Application under the *Agricultural Operation Practices Act* for a confined feeding operation, manure collection area, and/or manure storage facility(ies)

<b>NRCB USE ONLY</b>	Application number	Legal land description
<input checked="" type="checkbox"/> Approval <input type="checkbox"/> Registration <input type="checkbox"/> Authorization <input type="checkbox"/> Amendment	<b>LA23044</b>	<b>NE 19-12-19 W4M</b>

**Re: Geotechnical Review and Evaluation  
NRCB Permitting of Existing & Proposed Feedlot Pens  
NE-19-012-19-W4M, near Turin, Alberta**

Figure 3: Detailed Pen & Catch Basin Plan

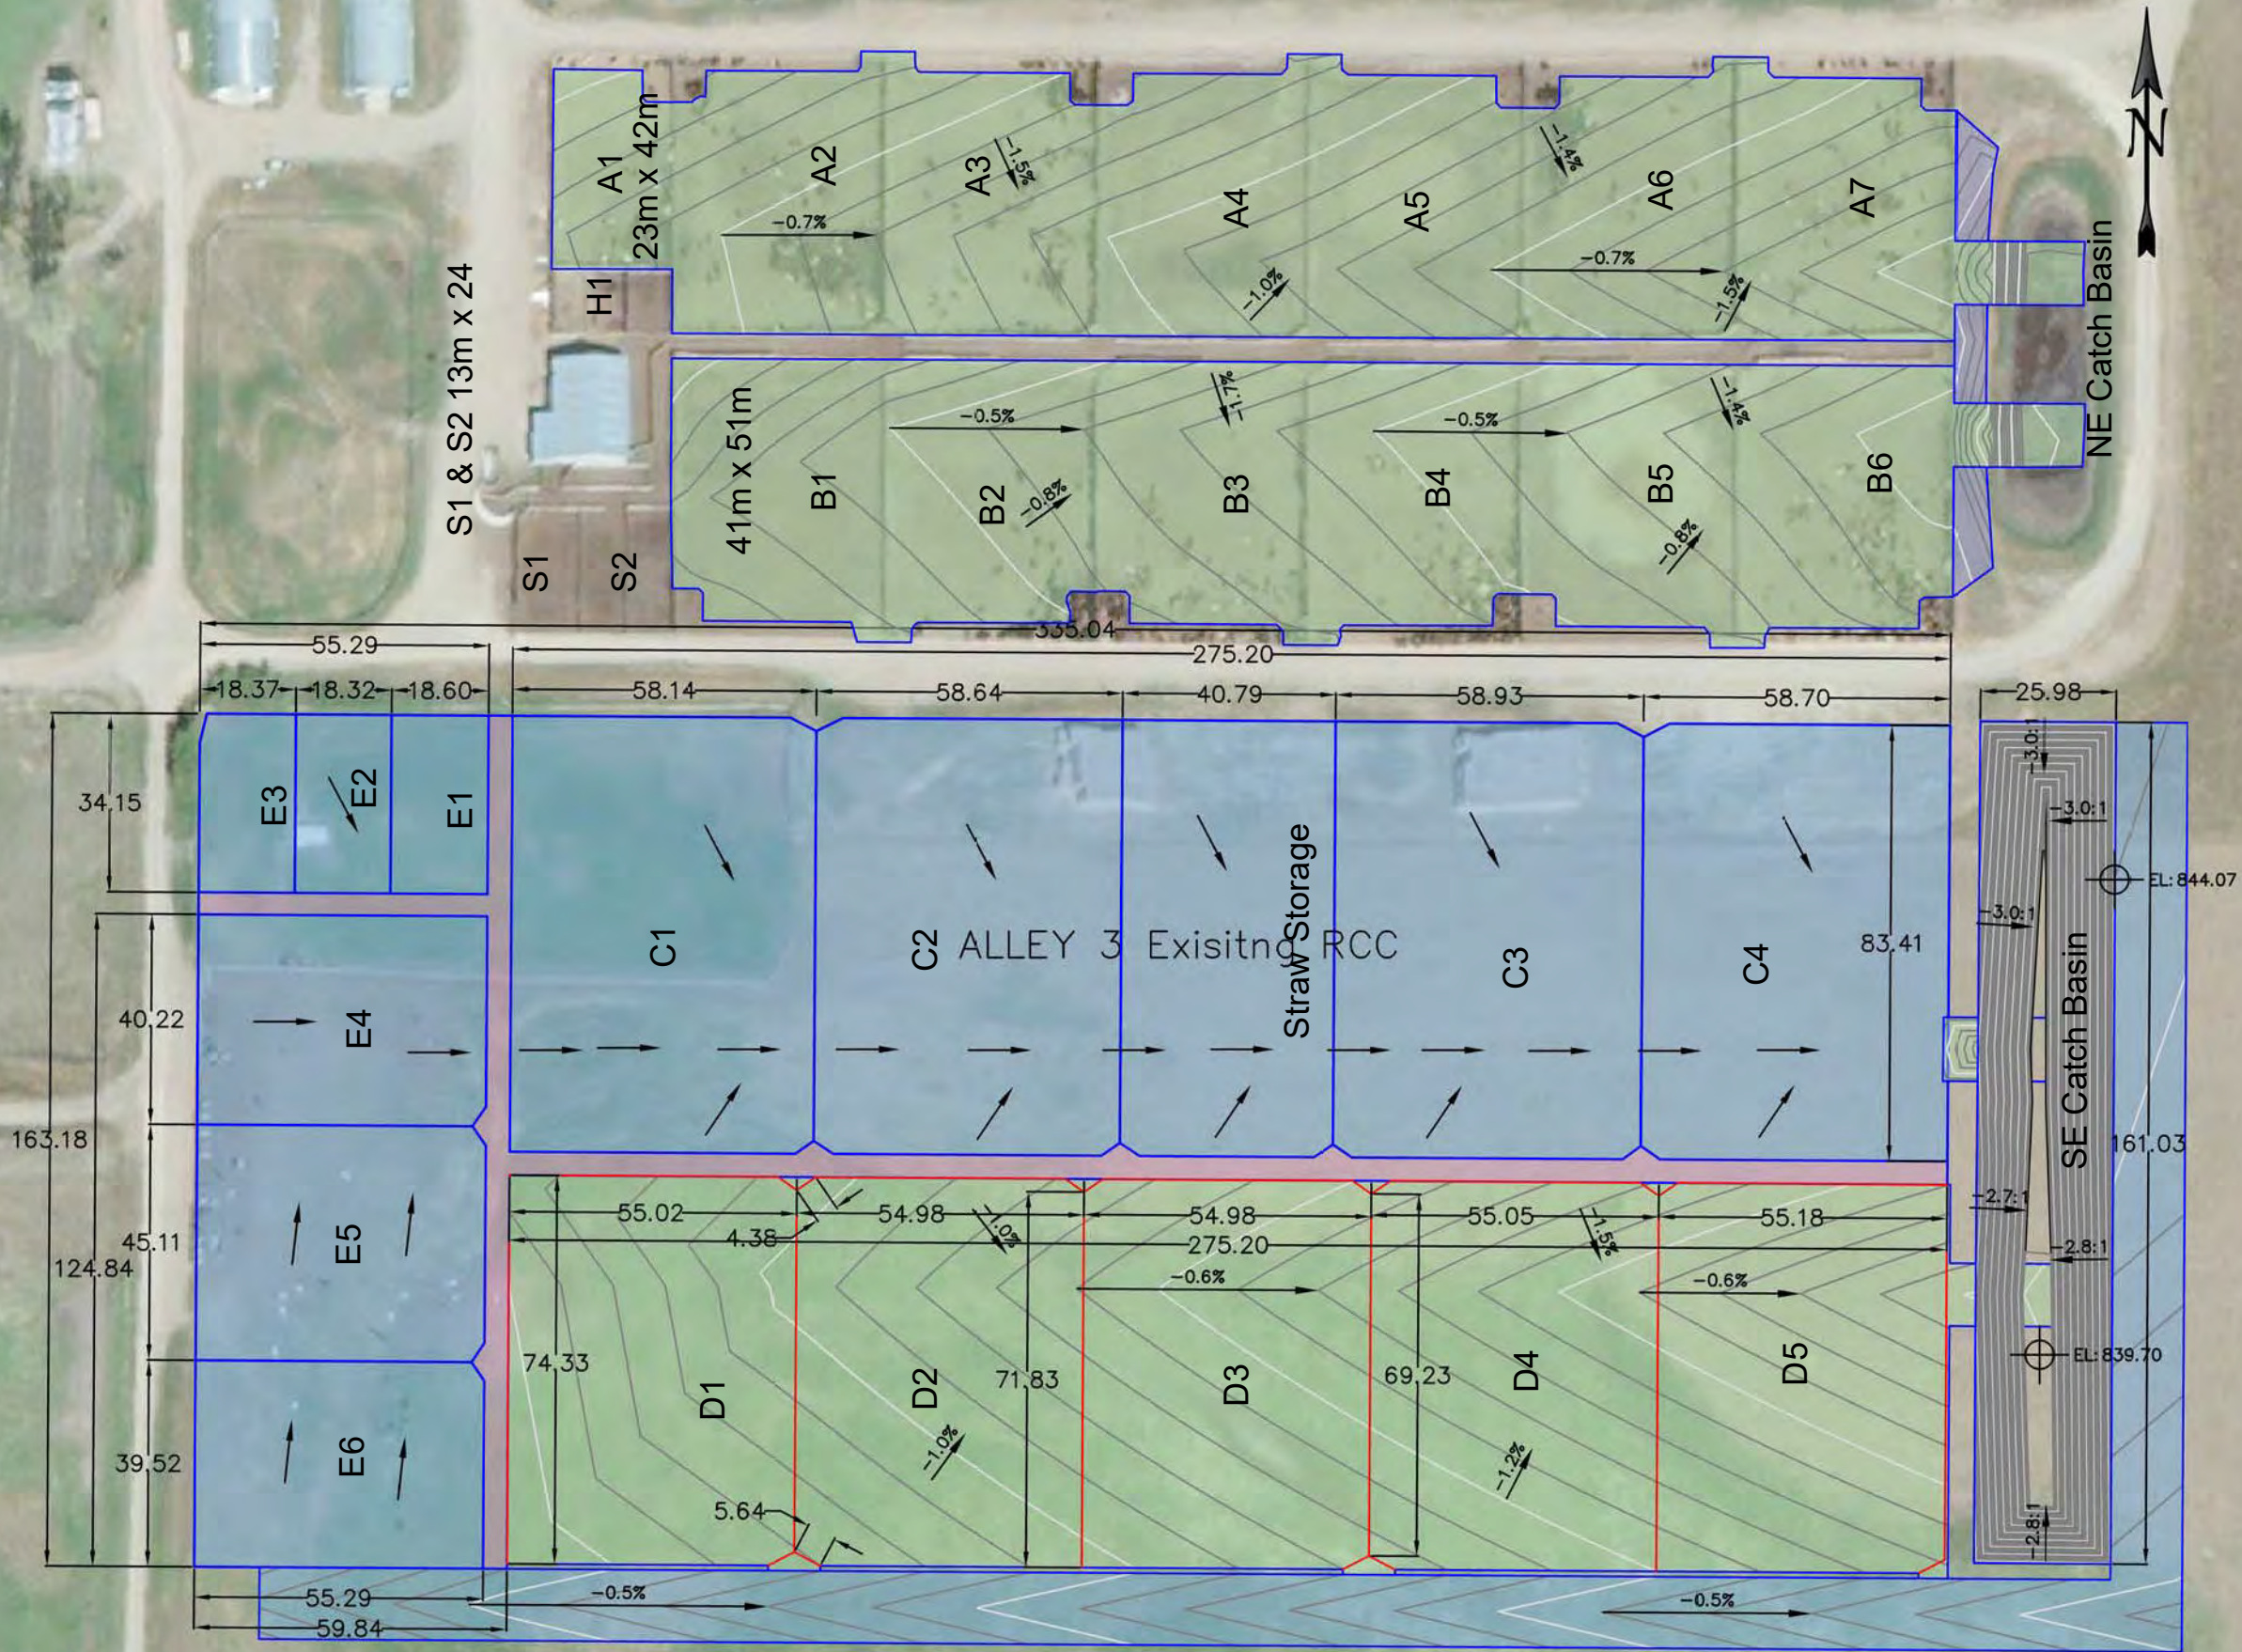
AO comment: As per email from Mr. Lobbezoo on September 11:RCC is already in place in pens C1-C4 and E1 to E6, except for the space for straw storage in the middle of row C. RCC is already in place in the historical feedlot as well, which would be rows A and B. D will also have RCC once the permit is in place.

AO comment: runoff will be capture in a catch basin lined with compacted clay. (see below)

# Catch Basin Storage Volume Calculator

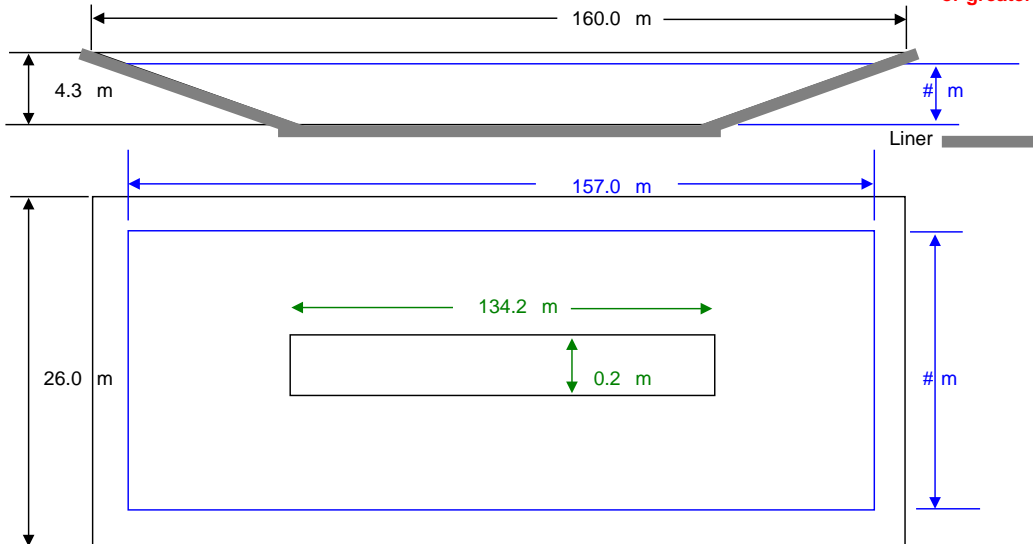
Runoff capacity requirements met: **Required for paved areas is 4,021 m<sup>3</sup>**  YES  NO

**Final compaction test required to prove that AOPA requirements are met. Report should be prepared by prof. engineer. A condition is required that construction shall cease immediately if the water table is within 1 m of the construction zone and the NRCB has to be notified.**
